From: <Joseph_Hegner@Dom.com>
To: <NXP1@nrc.gov>
Date: Thu, Apr 13, 2006 6:20 PM
Subject: North Anna ESP Application Revision 6

DOMINION NUCLEAR NORTH ANNA, LLC
NORTH ANNA EARLY SITE PERMIT APPLICATION
RESPONSE TO NRC QUESTIONS AND REVISION 6 TO THE NORTH ANNA ESP
APPLICATION

Enclosure 1
Dominion Response to March 2 and
March 13, 2006 NRC Questions

Figure 1: Flow Reduction ($\Delta Q = Q_2 - Q_3$) over Dam (from October 1978 to April 2003)

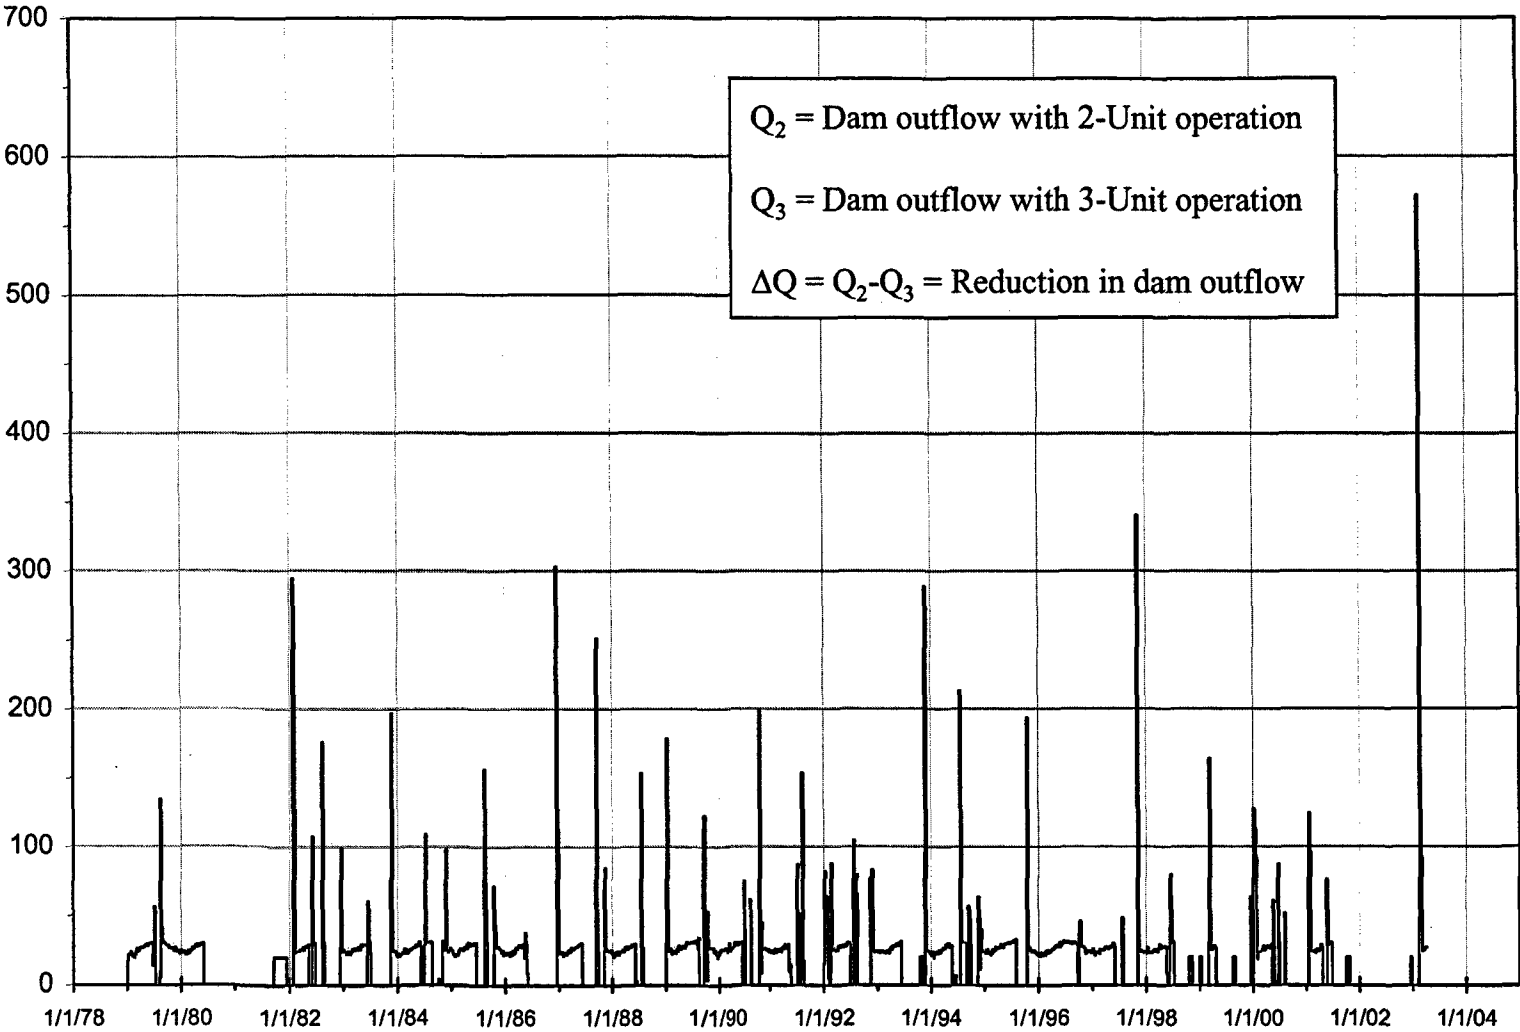
- a. Section 5.2.2.2 states that the frequency of reduced flow from the dam would increase. Provide an analysis of the impact on fish and other aquatic communities in the North Anna River downstream of the dam. Specifically, address how the reduced water flow rates would affect environmental conditions at known striped bass spawning habitat areas during the striped bass spawning season.**
- b. Dominion's RAI response dated April 12, 2005, stated that Dominion planned to provide assistance to aid the Virginia Department of Game and Inland Fisheries (VDGIF) in development and stocking of a more thermally tolerate species, such as a sterile white bass/striped bass hybrid. Given the change to the cooling system, does Dominion still plan to provide this assistance?**

Dominion's flow analysis focused on two points in the river system: (1) at the dam, which is representative of the lower North Anna River, and (2) at the Hanover USGS gauging station on the Pamunkey River about 46 miles downstream from the dam and about 25 miles upstream of the Hwy 360 Bridge (which is upstream of tidal influence and representative of freshwater flows into the downstream striped bass spawning areas, although it does not include added fresh water flow from small tributaries downstream of Hanover).

The change in flow at the dam due to Unit 3 operation was calculated using the estimated weekly-average flows over the dam for two and three units for the period from October 1978 to April 2003. The period 1978-to-2003 was considered representative of flows expected in the future, including both wet and dry years. Flows in the Pamunkey River for the 3-unit operation were obtained by subtracting from the recorded flow at the Hanover gauge the estimated flow change at the dam between the existing condition and the expected future condition with Unit 3 operation. The flow values were calculated using a "running"

7-day average recorded as daily averages at the Hanover gauge, while allowing a 2 day travel time for the flow from the North Anna Dam to reach the Hanover gauge. This assumes a velocity of about 1.5 fps (feet per second) in the free-flowing North Anna River. This approach is physically reasonable and it accounts for the travel time from the dam to the gauging station, which is not accounted for by simply subtracting a daily North Anna flow change from the daily flow at the Hanover gauge.

Certain characteristics of the changes in flow at the dam between 2-unit and 3-unit operation are apparent from these calculations as illustrated in Figure 1:

- There are short periods with a difference of 20 cfs, e.g., when 2-unit operation is releasing 40 cfs minimum flow, but 3-unit operation, with a lower lake level, would release 20 cfs, which would have occurred seven times in the 1978-to-2003 period, lasting one week to 3 months;

- There are periods when the 2-unit dam release is much larger (up to 550 cfs, but mostly 100 to 350 cfs) than the 3-unit release, due to the fact that runoff after a dry period fills the reservoir level to elevation 250 ft more rapidly for the 2-unit case and nearly all the river inflow is passed over the dam for a short period before the reservoir would have filled under the 3-unit scenario. Flow differences above 100 cfs would have occurred approximately 25 times in the 1978-to-2003 period, with each episode lasting a few days to two weeks.
